August 29, 2017

## Removal of Tubing Clamp SNP6 on Lid of Water Block WAB and Exchange of Silicone Tubing • Dialog iQ

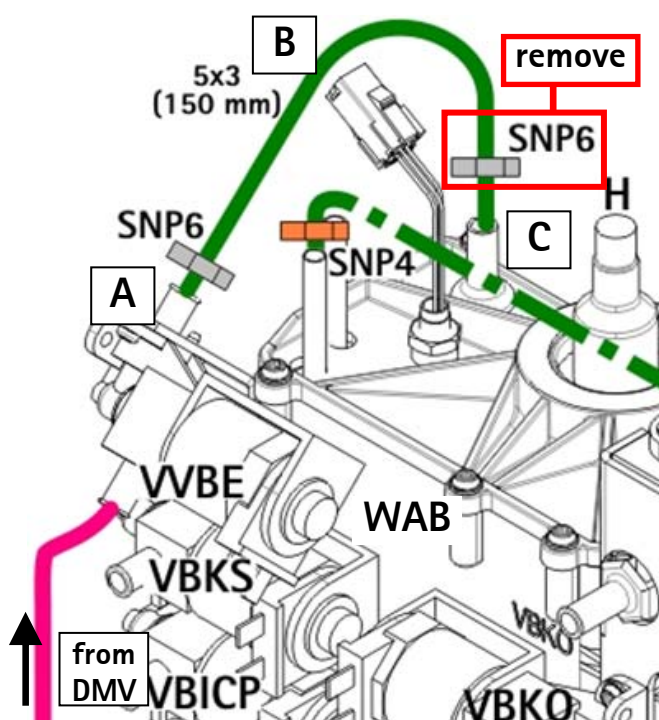
The water inlet silicone tubing at the inlet tank VB on the lid of the water block WAB can slip off from the tubing connector, especially if the central heat disinfection is used.

The pressure pulsation at the water inlet in conjunction with hot incoming water via VVBE (from DMV) can lead to the silicone tubing 5x3 slipping off the tubing connector at the lid of the water block to the inlet tank. The tubing clamp SNP6 at the tubing connector C increases this situation.

1. Turn off Dialog iQ, disconnect water inlet tubing from wall outlet to ensure pressure free water inlet, and open doors.
2. Remove both tubing clamps SNP6 at A and C, and then remove silicone tubing B between A and C.
3. Replace this silicone tubing by new silicone tubing (5x3, 150 mm length).

**Note:** Silicone tubing is replaced to ensure a tight seating at tubing connector C. It has to be dry and free of any lubricant.

**Note:** Do not reconnect the tubing clamp SNP6 at tubing connector C.

4. Secure silicone tubing B at A with tubing clamp SNP6.
5. Connect water inlet tubing from wall outlet and switch to TSM service program, *Low Level Test, 1.9 Water Inlet, Inlet Tank and Flow Pump FPE*, to check water inlet part for leakages.
6. Close doors and perform a test run in treatment mode with a subsequent disinfection, as described in chapter 5 of the Dialog iQ service manual.
